# ML WAVEFORMS

MODEL #:	DATE:	DESCRIPTION:
ML-S PREAMP	6-27-90	STANDARD PREAMP
DESIGNED BY:	BOARD #:	PCO#-DATE:
R.G./M.J.	406-00730	10 - 6/90

GALLIEN-KRUEGER		MODEL #:	DATE:	DESCRIPTION: EFFECTS PREAMP,
SHEMATIC PG: 1 OF 2		ML-E PREAMP	10-24-90	LEAD & CLEAN CHANNELS
		DESIGNED BY: M.P.J.	BOARD #:	PCO#-DATE: FROM SN: TO SN:
			406-0063E	10 - 6/90

GALLIEN-KRUEGER		PRODUCTION CHANGE ORDER		PCO#: 10			
DATE: 6/18/90		ASSEMBLY #: 406-0063E(£ 0073D)		MODEL#: ML			
ASSEMBLY DESCRIPTION: E and 5 preamp boards				PAGE 1 OF 1			
AFFECTS OPTIONS: <input checked="" type="checkbox"/> ALL <input type="checkbox"/> 100V <input type="checkbox"/> 120V <input type="checkbox"/> 220V <input type="checkbox"/> 240V <input type="checkbox"/> 50HZ <input type="checkbox"/> 60HZ							
TYPE OF CHANGE: <input type="checkbox"/> NECESSARY TO THE FUNCTION OF THE UNIT <input checked="" type="checkbox"/> IMPROVEMENT OR ADDITION TO THE UNIT <input type="checkbox"/> OTHER _____							
CHANGE TO BE IMPLEMENTED TO: <input checked="" type="checkbox"/> NEXT PRODUCTION RUN <input checked="" type="checkbox"/> ALL UNITS IN PRODUCTION <input checked="" type="checkbox"/> ALL UNITS IN STOCK <input type="checkbox"/> ALL UNIT

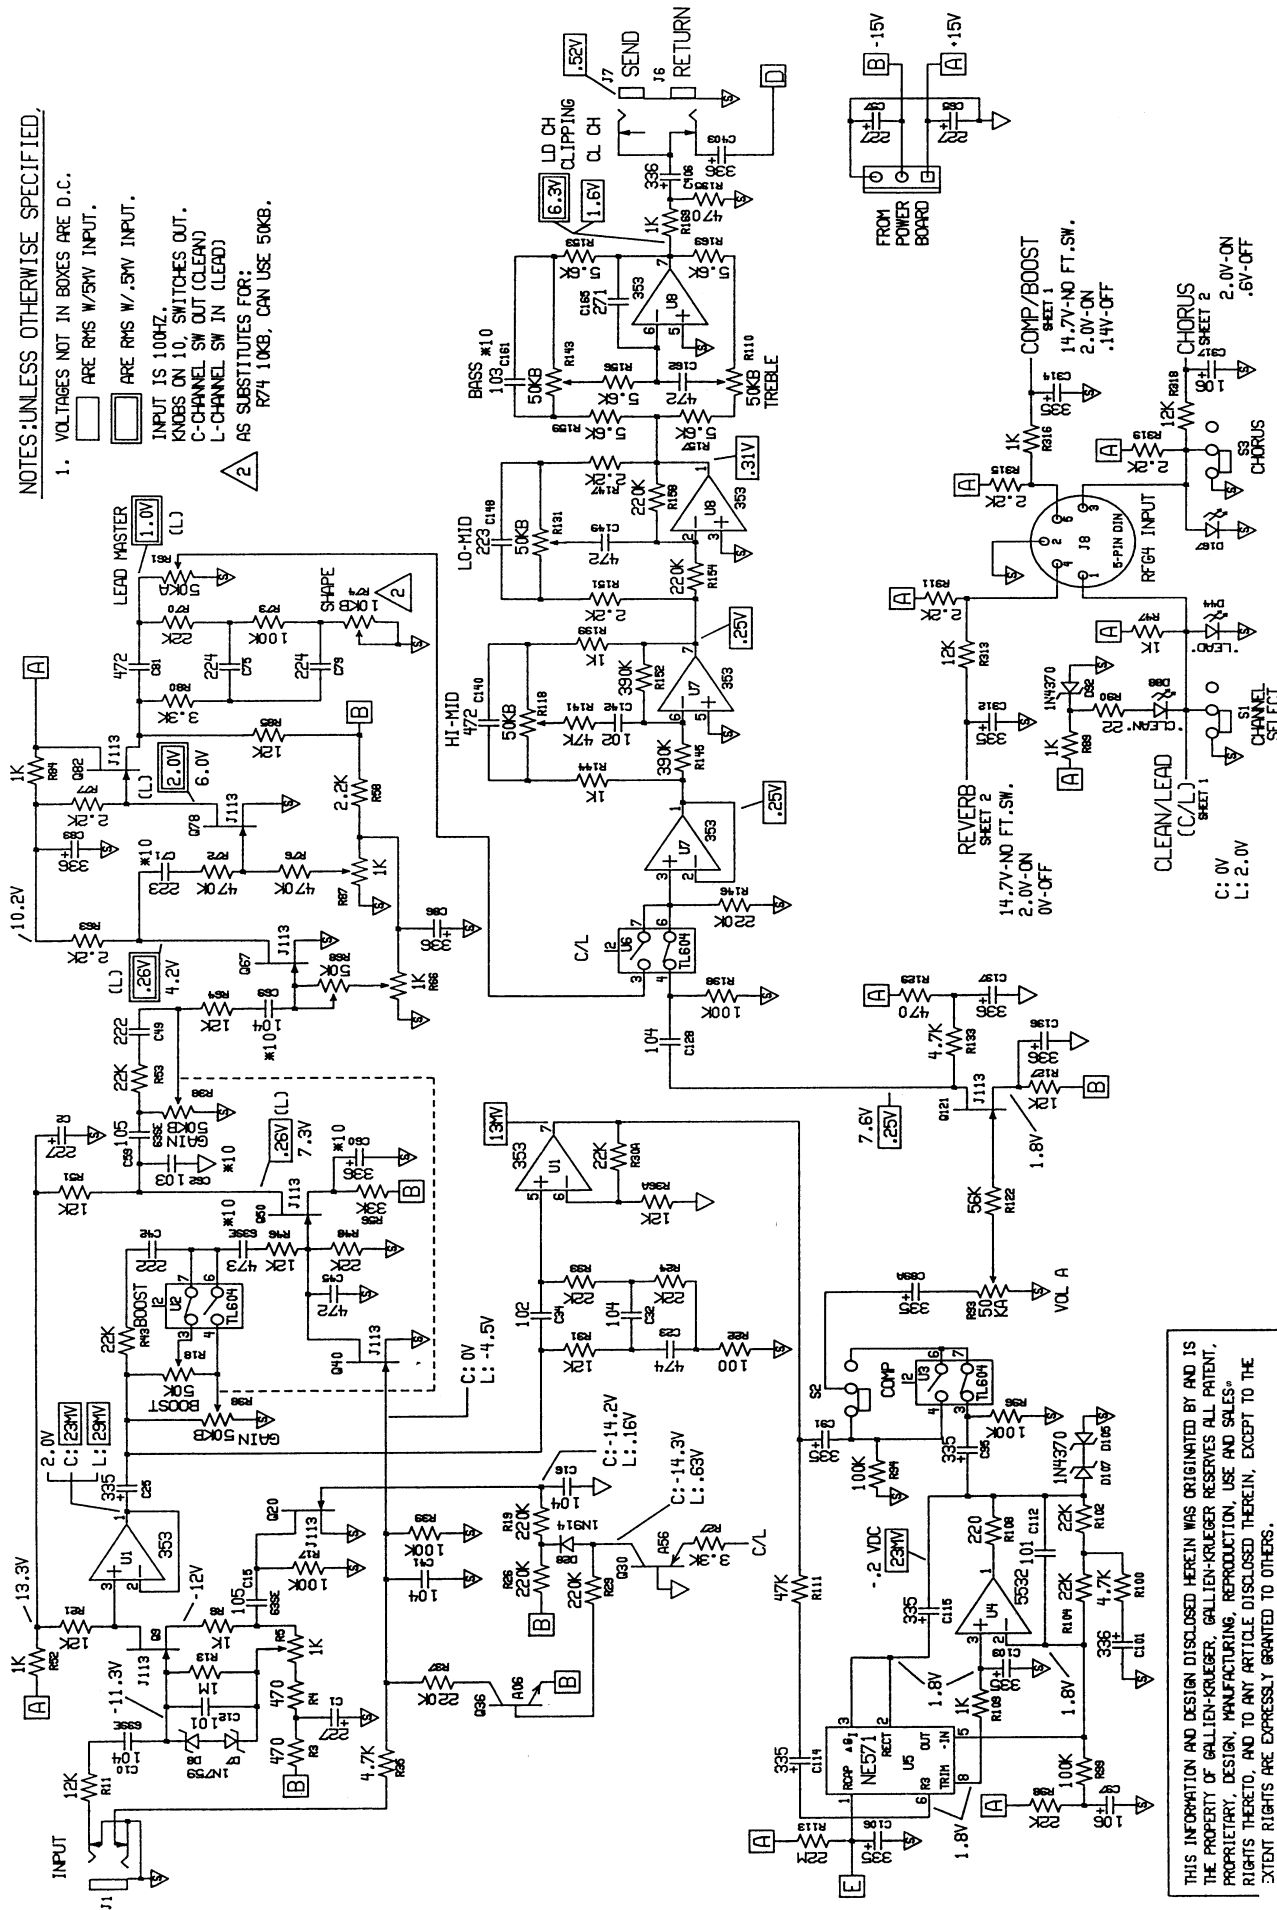
BEGINNING SERIAL NUMBER AFFECTED:							
DESCRIPTION OF CHANGE: <input type="checkbox"/> SEE PCO SUPPLEMENTS <input type="checkbox"/> CONTINUED ON PCO SUPPLEMENT PAGE _____ Note: Values in parenthesis refer to 5-preamp board - if not they refer to E-preamp 1. Change C60(C62) from 107(227) cap to a 336 cap 2. Add 103 from drain of Q50(Q48) to gnd. (Goes in space marked C62 (C66)) 3. Change C69(C71) from 335 to 104/635E cap 4. change C71(C64) from 224 to 223 cap 5. Lift one side of R46(R44), a 12K res. Lift the side away from the front panel. 6. Solder in a 473/635E cap between the lifted lead and the hole it used to occupy.							
REASON FOR CHANGE: Change the dead channel sound in the high gain mode to have a little more "crunch".							
PARTS ADDED			PARTS DELETED				
PART#	DESCRIPTION	QTY.	REF. DES.	PART#	DESCRIPTION	QTY.	REF. DES.
032-8473	473/635E cap			031-1227	227 cap		C60(C62)
038-0336	336L cap		C60(C62)	030-1103	103 cap		C62(C66)

030-1103	103 cap		C62(C66)	038-2335	335 cap		C69(C71)
032-3104	104/635E cap		C69(C71)	030-2224	224 cap		C71(C64)
030-0223	223 cap		C71(C64)				
<input type="checkbox"/> CONTINUED ON PAGE _____			<input type="checkbox"/> CONTINUED ON PAGE _____				
AFFECTED AREAS	DONE BY	DATE	AFFECTED AREAS (CONT)	DONE BY	DATE		
<input checked="" type="checkbox"/> CIRCUIT SCHEMATIC	MEI	6-19-90	<input type="checkbox"/>				
<input checked="" type="checkbox"/> BILL OF MATERIAL	BA	6-19-90	<input type="checkbox"/>				
<input checked="" type="checkbox"/> AUTO INSERTER	MV	6-19-90	<input type="checkbox"/>				
<input checked="" type="checkbox"/> SAMPLE CHANGE	MG	6/18/90	DOCUMENT DIST. LIST	# COPIES			
<input checked="" type="checkbox"/> TEST PROCEDURE			<input checked="" type="checkbox"/> GK USA				
<input type="checkbox"/> COMP. CONTROL FORM			<input checked="" type="checkbox"/> GK EUROPE				
<input type="checkbox"/> FAB DRAWING			<input checked="" type="checkbox"/> GK CAMPBELL

MODEL #:	DATE:	DESCRIPTION:
ML PWR AMP	2-11-91	130 WATTS
DESIGNED BY:	BOARD #:	PCO#-DATE:
A.MITHALKA	0078	FROM SN# TO SI
	00280	24 - 9/90

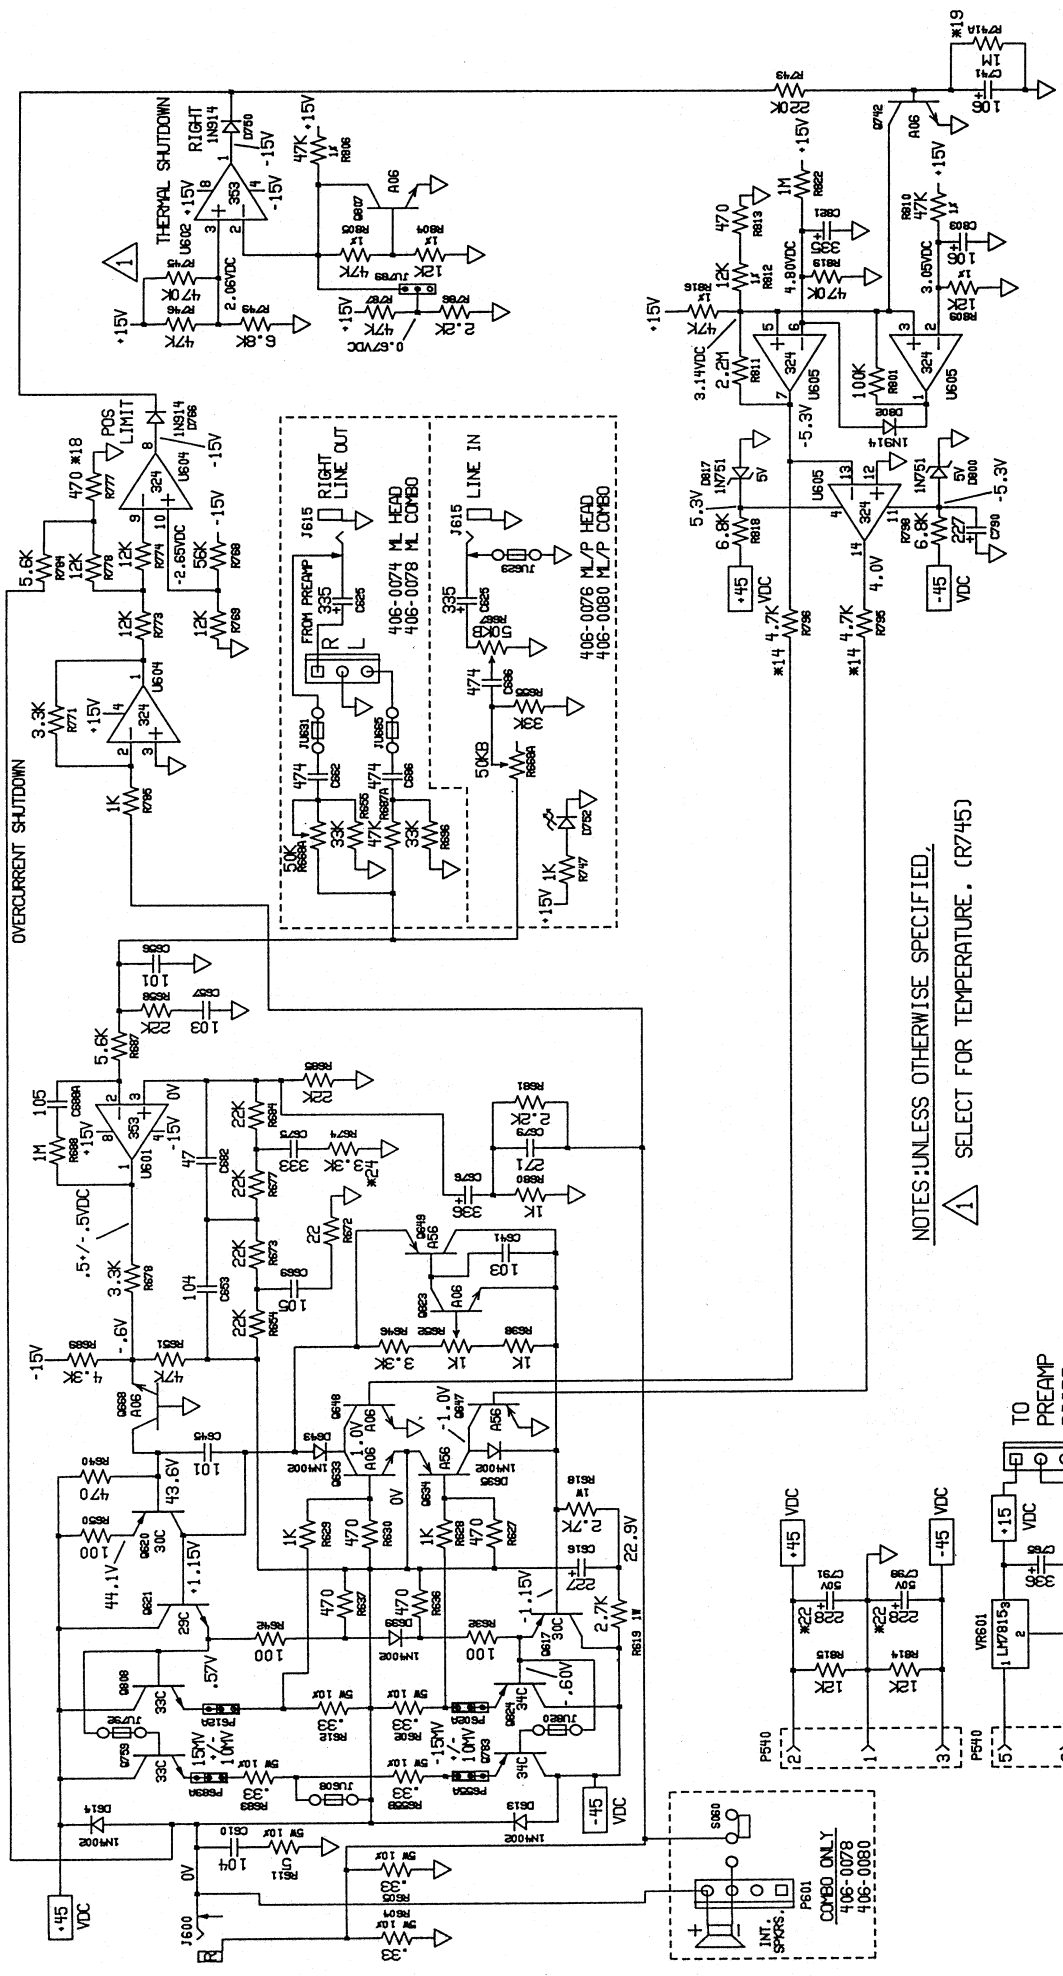
DESCRIPTION OF CHANGE:  SEE PCO SUPPLEMENTS  CONTINUED ON PCO SUPPLEMENT PAGE \_\_\_\_\_  
 Change R794, R795, R796, R797 from 22K to 4.7K.

REASON FOR CHANGE: Ensures clamping output, even with A06's having minimum  $\beta$ .

DESCRIPTION OF CHANGE:  SEE PCO SUPPLEMENTS  CONTINUED ON PCO SUPPLEMENT PAGE \_\_\_\_\_  
 Change R777 and R761 from 470Ω to 390Ω.

REASON FOR CHANGE:  
 Resistors are typically paralalled with these to get lower value.

Change R777 and R761 from 390Ω to 470Ω.

REASON FOR CHANGE:  
De-sensitize overload trip point.

DESCRIPTION OF CHANGE:  SEE PCO SUPPLEMENTS  CONTINUED ON PCO SUPPLEMENT PAGE \_\_\_\_\_  
Add bleeder resistor across C741. Resistor is 1MΩ.

REASON FOR CHANGE: Bleed charge due to flux leakage current around Q742. C741 is 10µf - and is connected base to emitter on Q742.

GALLIEN-KRUEGER		MODEL #:	DATE:	DESCRIPTION: 125W/100KHZ
SCHEMATIC PG: 1 OF: 1		MICRO SERIES	10-9-90	POWER SUPPLY
		DESIGNED BY:	BOARD #:	PCO#-DATE: FROM SN# TO SN:
		A.MIHALKA	406-0071E	26 - 10/90

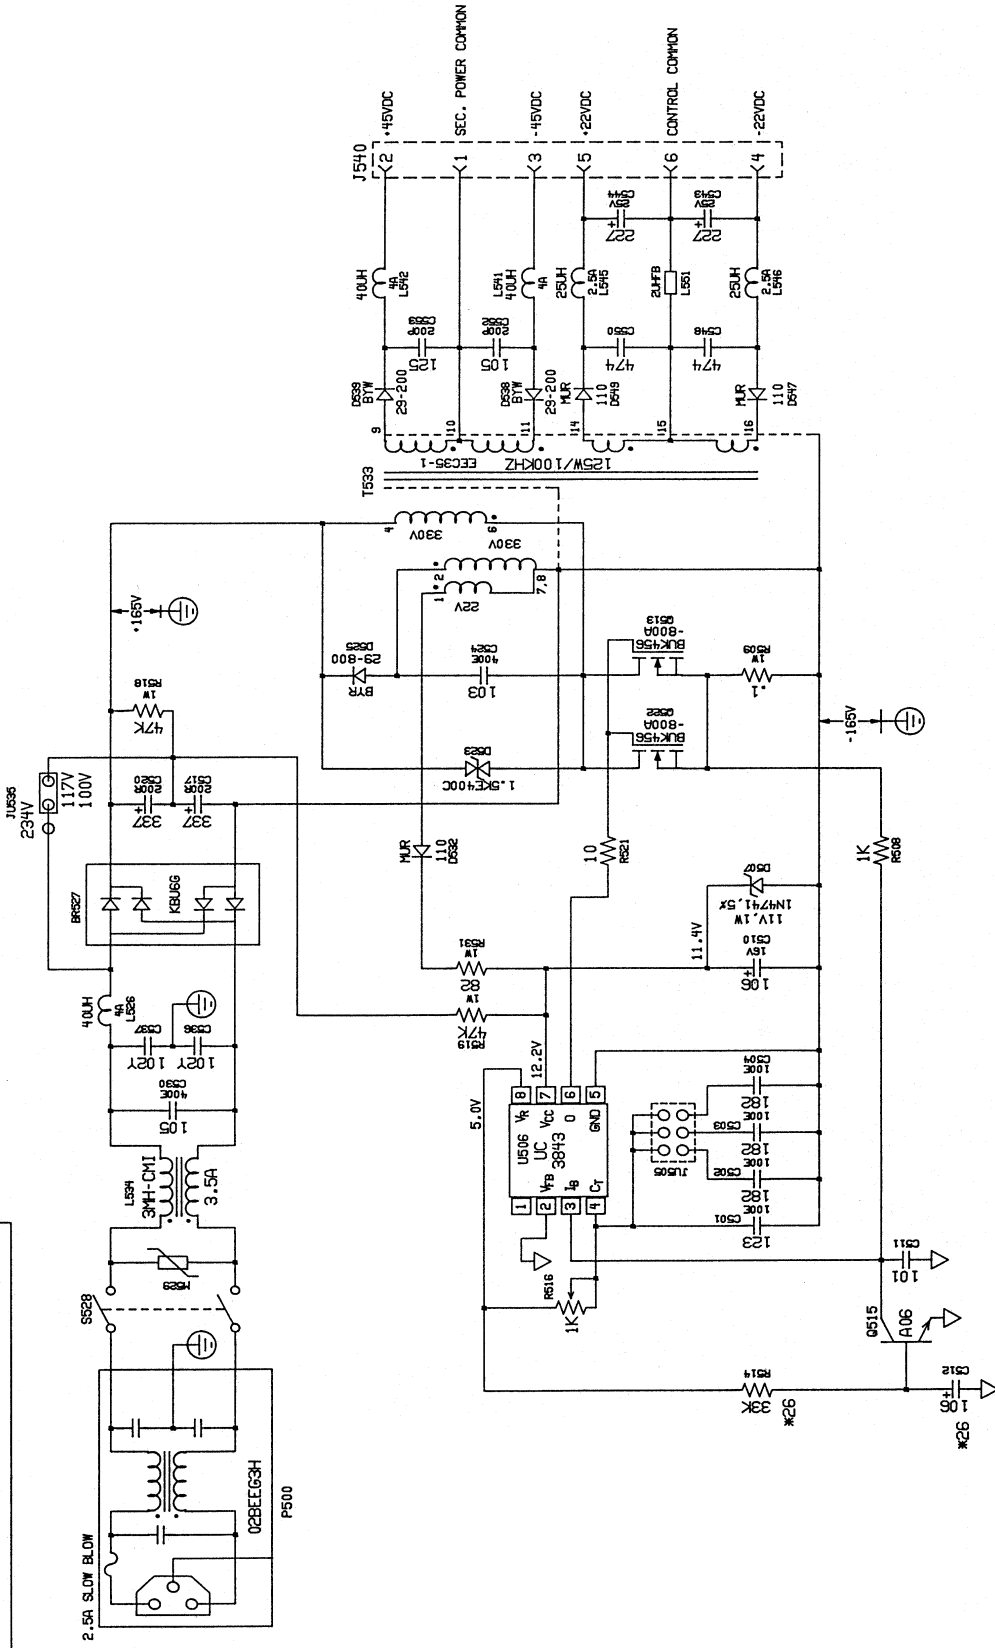
Change C504 from 152 to 182.  
 Change C505 from 102 to 182.

REASON FOR CHANGE:  
 New batch of transformers requires longer period, lower frequency.
